Before the
Federal Communications Commission
Washington, D.C. 20554

In the matter of)	
)	
ARINC Incorporated)	File Nos. SES-LIC-20030910-01261
)	SES-AMD-20031223-01860
Application for Blanket Authority for Operation)	
of Up to One Thousand Technically Identical)	
Ku-Band Transmit/Receive Airborne Mobile)	
Stations Aboard Aircraft Operating in the)	
United States and Adjacent Waters)	
)	
)	
)	
)	
)

ORDER AND AUTHORIZATION

Adopted: April 5, 2005

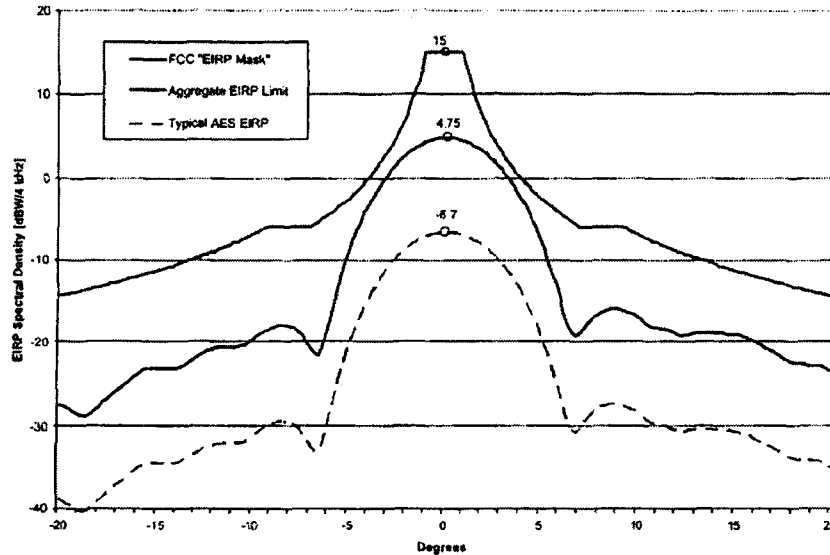
24. The SKYLink System operates with an Aloha/CDMA access protocol that allows multiple simultaneous co-frequency AES transmissions, relying on code differentiation to minimize self-interference. Because SKYLink AES antennas are not large enough to suppress side-lobe gain to the extent necessary for conformance with the limits in Section 25.209(a)(1), ARINC proposes to compensate by limiting AES input power density to levels well below the -14 dBW/4kHz limit for routinely-authorized digital VSAT Earth stations. ARINC determined that if the aggregate input-power spectral density of simultaneously-transmitting co-frequency SKYLink AES terminals does not exceed -24.25 dBW/4kHz, the system’s aggregate uplink off-axis e.i.r.p. density will not exceed a one-dB margin

below the VSAT emission envelope at the worst-case angle, as depicted by the following diagram.³⁴

ARINC asserted in its application that the input power density into a single SKYLink AES terminal would never exceed -24.25 dBW/4kHz and that the aggregate input power density into simultaneously-transmitting SKYLink AES terminals would be kept below that level *almost* all the time, through dynamic network control of AES power, log-ins, and data transmission rates.³⁵ Specifically, ARINC estimated that with 214 SKYLink AES terminals logged in over one transponder the probability of aggregate earth-station on-axis e.i.r.p. density exceeding the -24.25 dBW/4 kHz level at any given point in time would be less than 0.001 percent.³⁶ ARINC asserted that the SKYLink NMS would authorize no more than 214 terminals to be logged in concurrently and therefore maintained that the system's aggregate off-axis e.i.r.p. would be within the VSAT emission envelope at least 99.999 percent of the time.³⁷
